Supplementary Design Report for State Significant Development Application (SSD6116)

francis-jones morehen thorp

Sydney International Convention, Exhibition and Entertainment Precinct - ICC Hotel

MARCH 2014

Evolution of Lantern element.

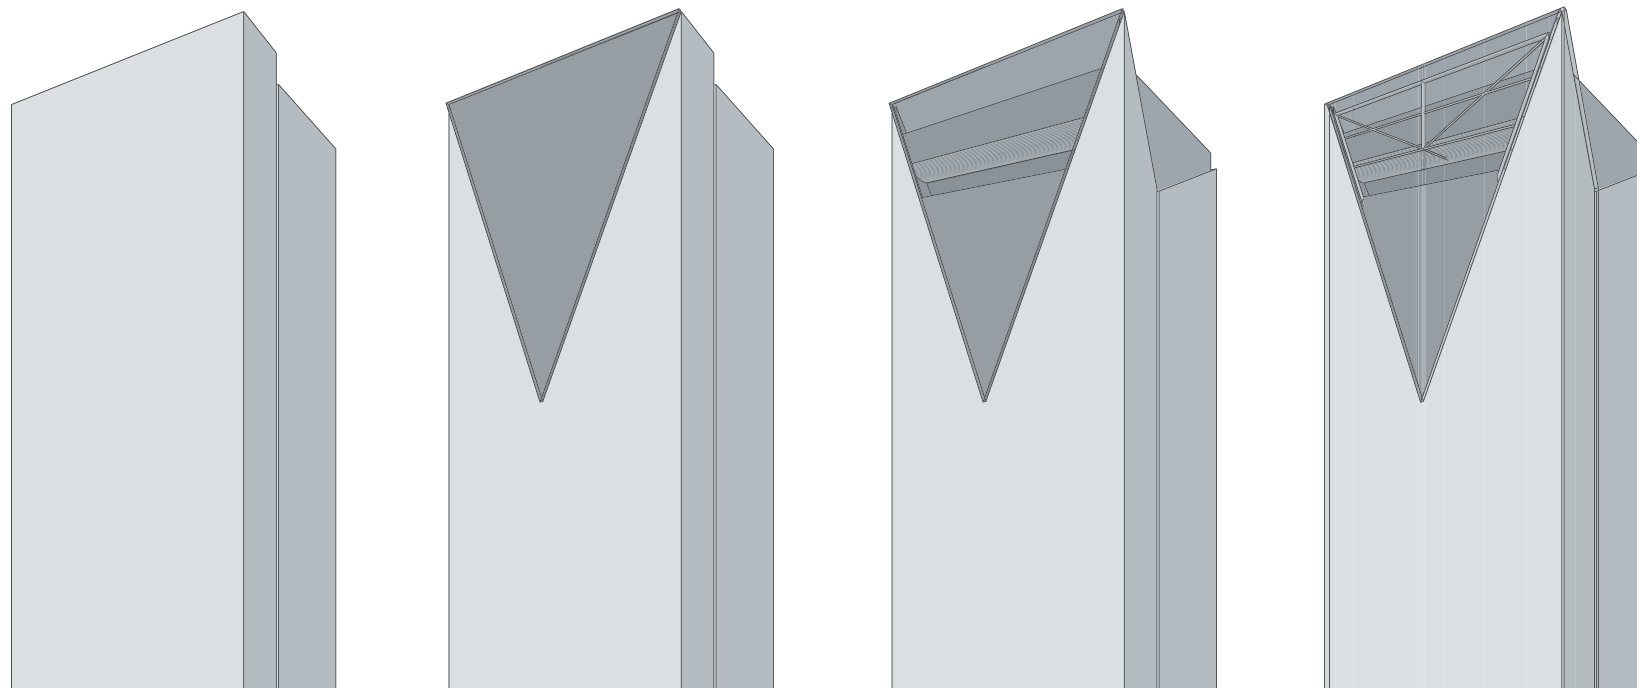
Section 5.1, Lantern Element of the Design Report as submitted in September 2013 described the concept for the lantern element as follows:

A key architectural element of the hotel is the extension of the slender north eastern volume of the tower above the main parapet line to form an identifiable 'lantern' in the skyline.

The 'lantern' is inspired by the concept of a lighthouse. This concept seeks to reinforce the gateway and landmark quality of the hotel as described elsewhere in this report.

The proposed 'lantern' element has been identified as an opportunity to ensure the tower positively contributes to the city's skyline with particular consideration of night time.

The revised proposal develops the lantern further into a glazed V shaped element at the top of the north east facade. This glazed V folds over the apex of the north east facade to form a transparent top to the tower. The V element includes hotel rooms to the lower portion and the club lounge area to the upper portion.

Increase sculpting of form - view from west

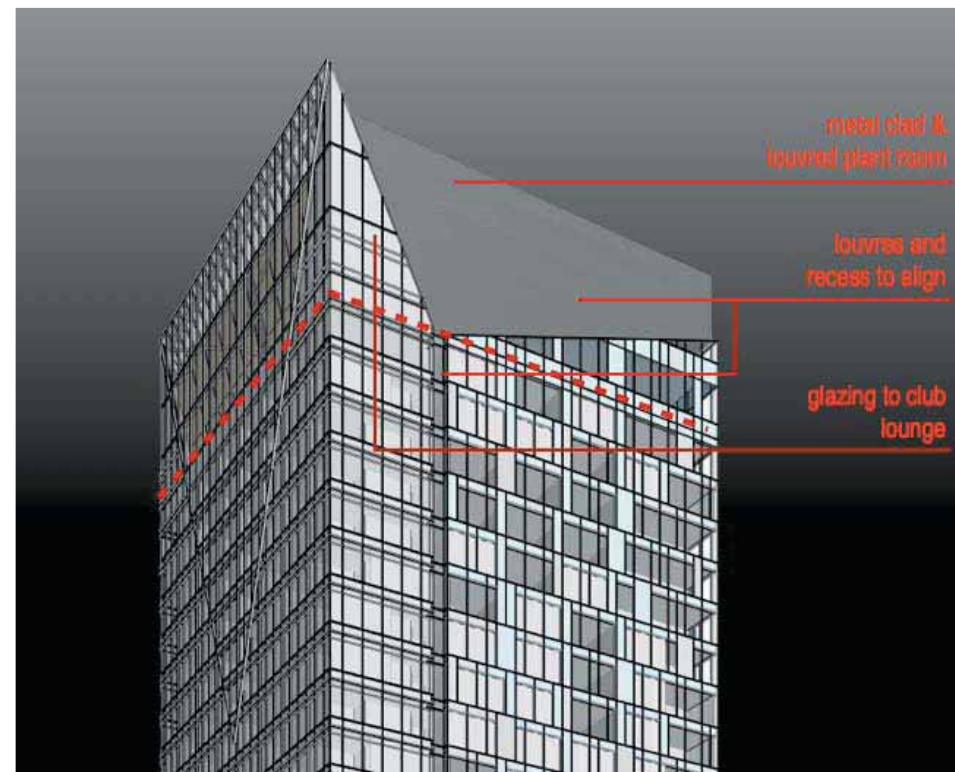
Section 5.8, Design Principles of the Design Report as submitted in September 2013 described the concept for the hotel's form as follows:

The design intent is to generate a contemporary and innovative architecture, vertically elegant and accentuated, setting the proposed hotel built form in subtle dialogue with the new ICC located immediately south of the site. The planning and architecture proposed seeks to express the massing and articulation of the hotel as a series of rectilinear tectonic elements which are composed to represent their overall individual forms which both articulate the podium and reinforce the vertical expression of the tower.

The revised proposal sees the expression of the rectilinear tectonic elements adjusted such that they have a more evolved, sculptural quality. The north east volume has been tapered at both the top and the bottom providing a distinctive, elongated form at both district and pedestrian scale. The top of the south western volume has also been tapered in elevation. This tapering opens the expressed gap between the two main volumes of the tower and provides for a more dynamic skyline expression.

Main facade - Relationship with north eastern facade

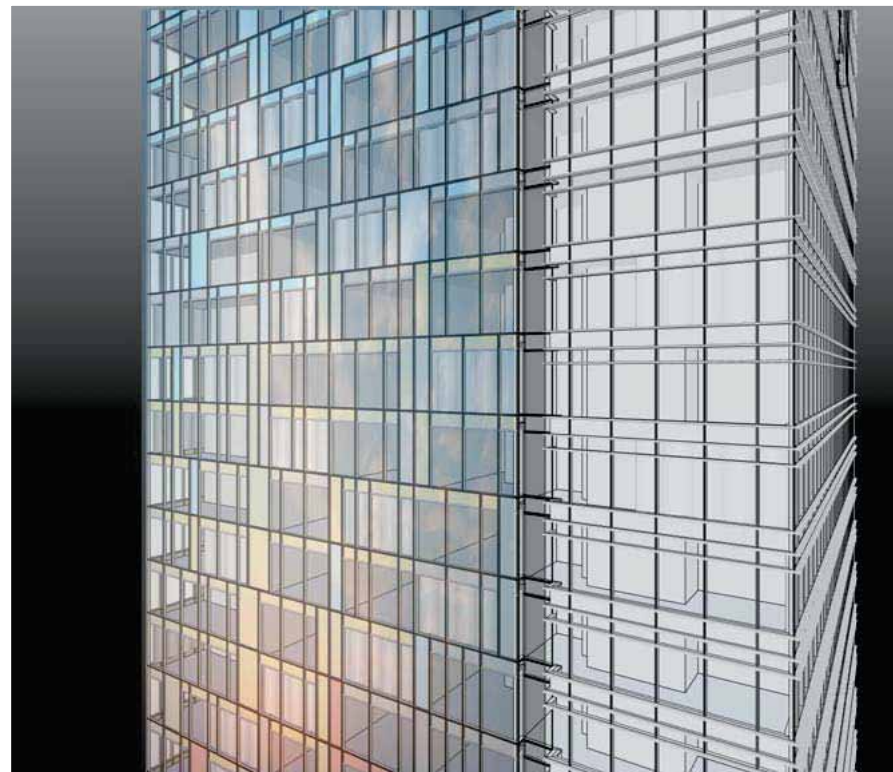
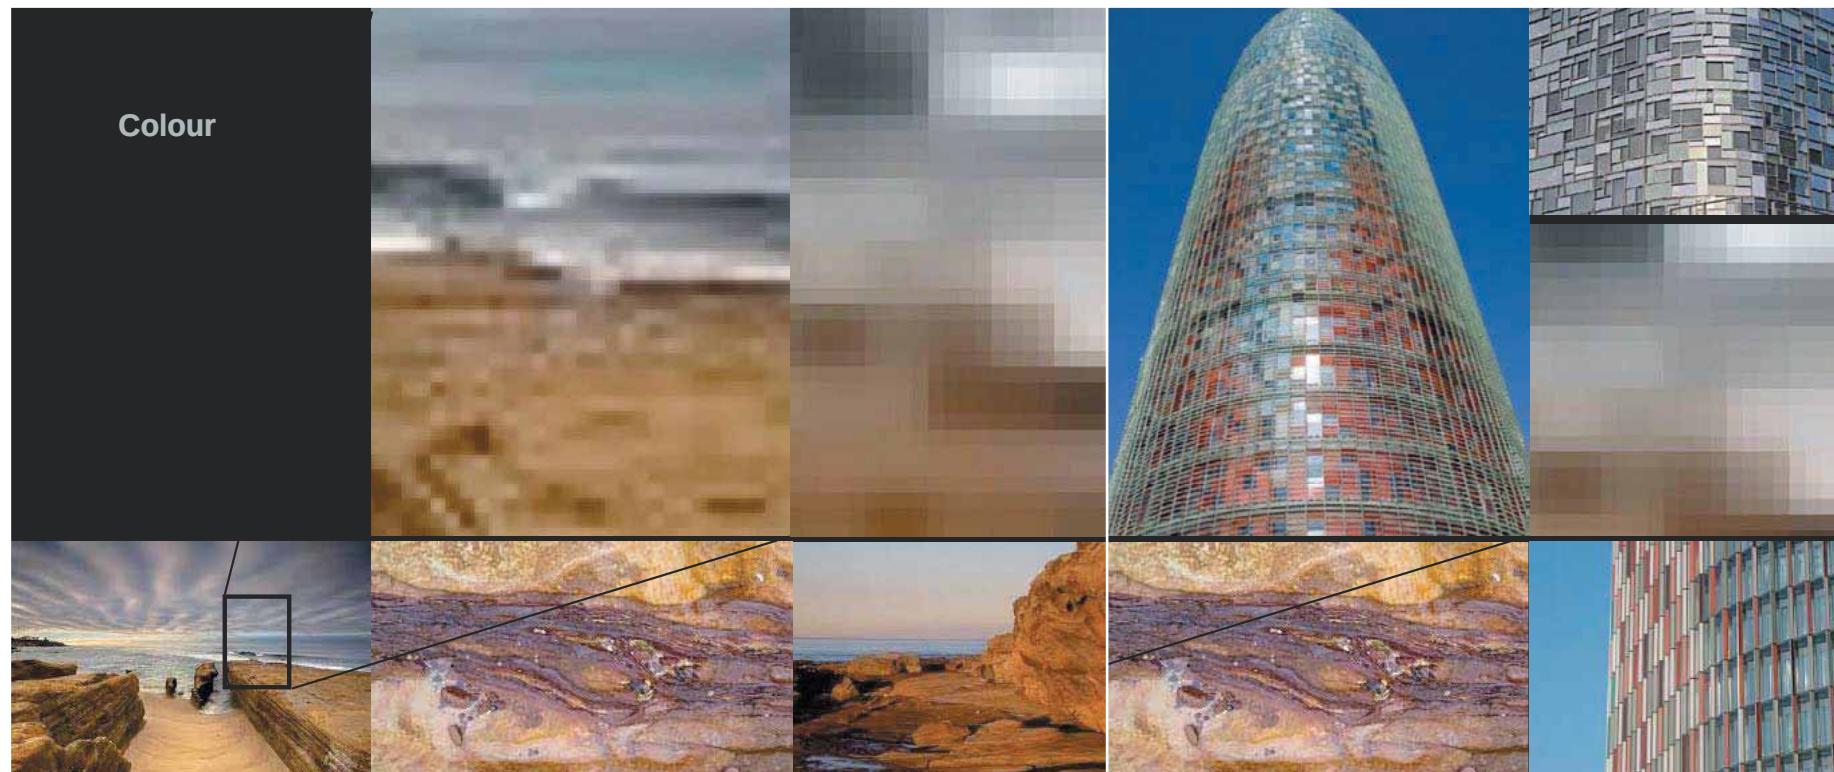
Section 5.8, Facades of the Design Report as submitted in September 2013 described the concept for the main tower facade as follows:

The main section of tower is expressed as a horizontally banded facade of alternating vision glass and metal spandrel. The spandrel portion of this facade is characterised by deep bronze tones. The spandrels are articulated with horizontal lines to give these facades depth and texture.

The horizontal treatment of this facade has been replaced by a vertically oriented, fully glazed curtain wall with a seemingly randomised mullion layout. The horizontal spandrel panels have been removed and replaced with full height glazing including coloured back pans aligning with the floor slab and ceiling zone. Coloured, full height glazed spandrel panels have also been introduced, to accentuate the vertical orientation and randomised quality of the facade. This approach will help the facade take on a pixelated quality, providing the tower a scaleless, object quality.

North East facade - overall view from east

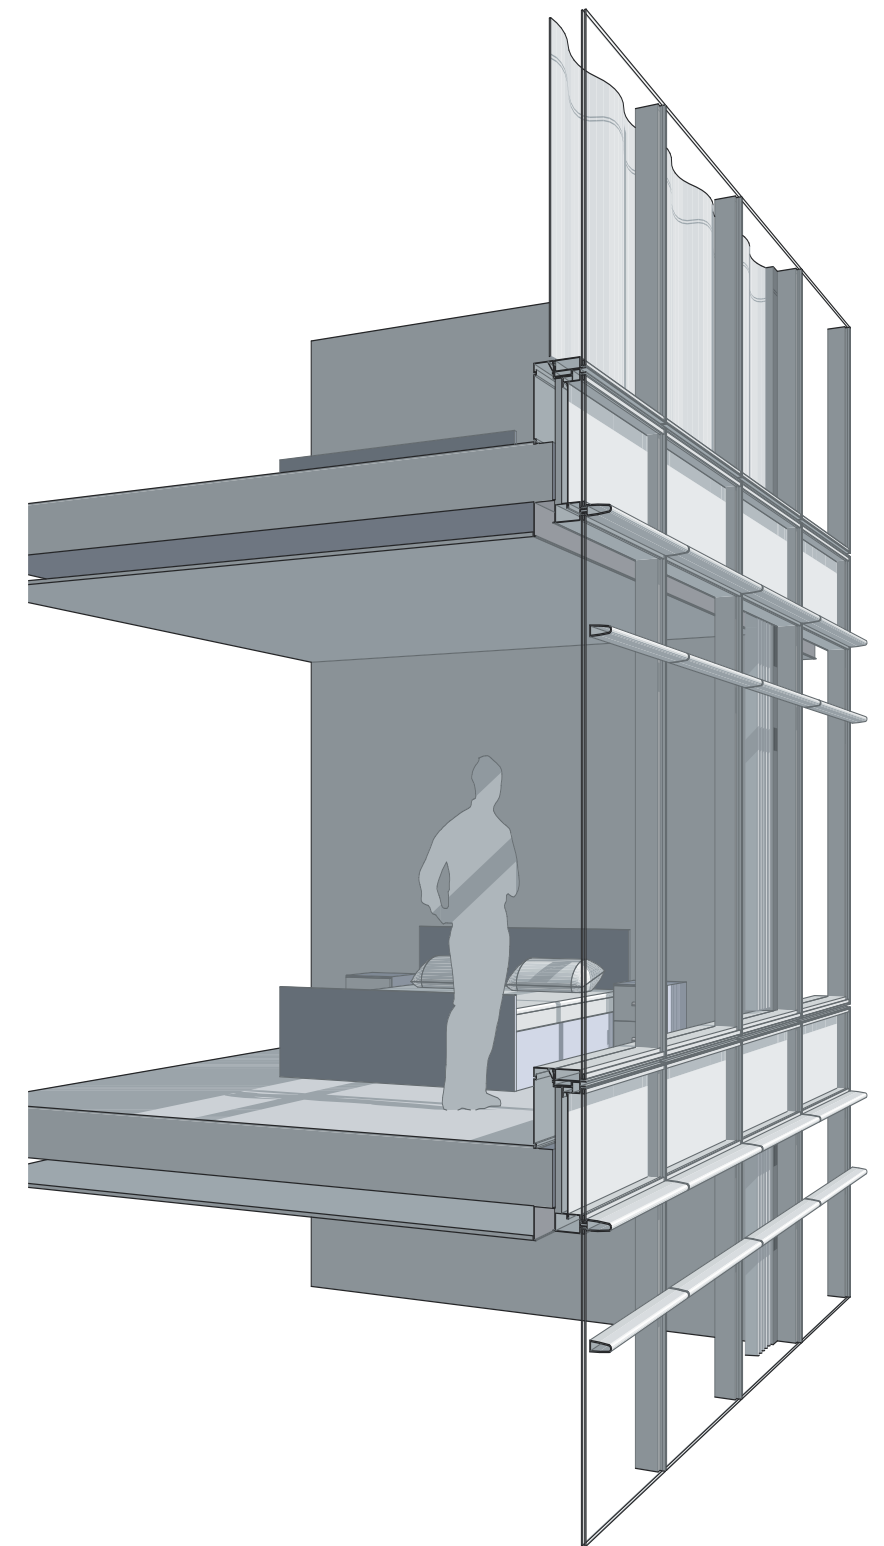
Section 5.8, Facades of the Design Report as submitted in September 2013 described the concept for the north east tower facade as follows:

The north eastern portion of the tower is expressed as a glazed 'white' volume. This section of tower facade will be fully glazed, employing full height Insulated Glazing Units (IGUs). The non vision panel sections of the facade incorporate a 'back pan' which straddles the slab edge with a limited zone above and below. This 'back pan' will be backed with white to give a visual depth to this portion of the facade. The drapes within the vision panel portion of this facade will be white. As the drapes are pulled or opened by the hotel occupants a highly desirable randomised and changing pattern will be created.

The essence of this concept has been retained with the facade still expressed as a white surface via the use of clear glass with white back pans and curtains behind.
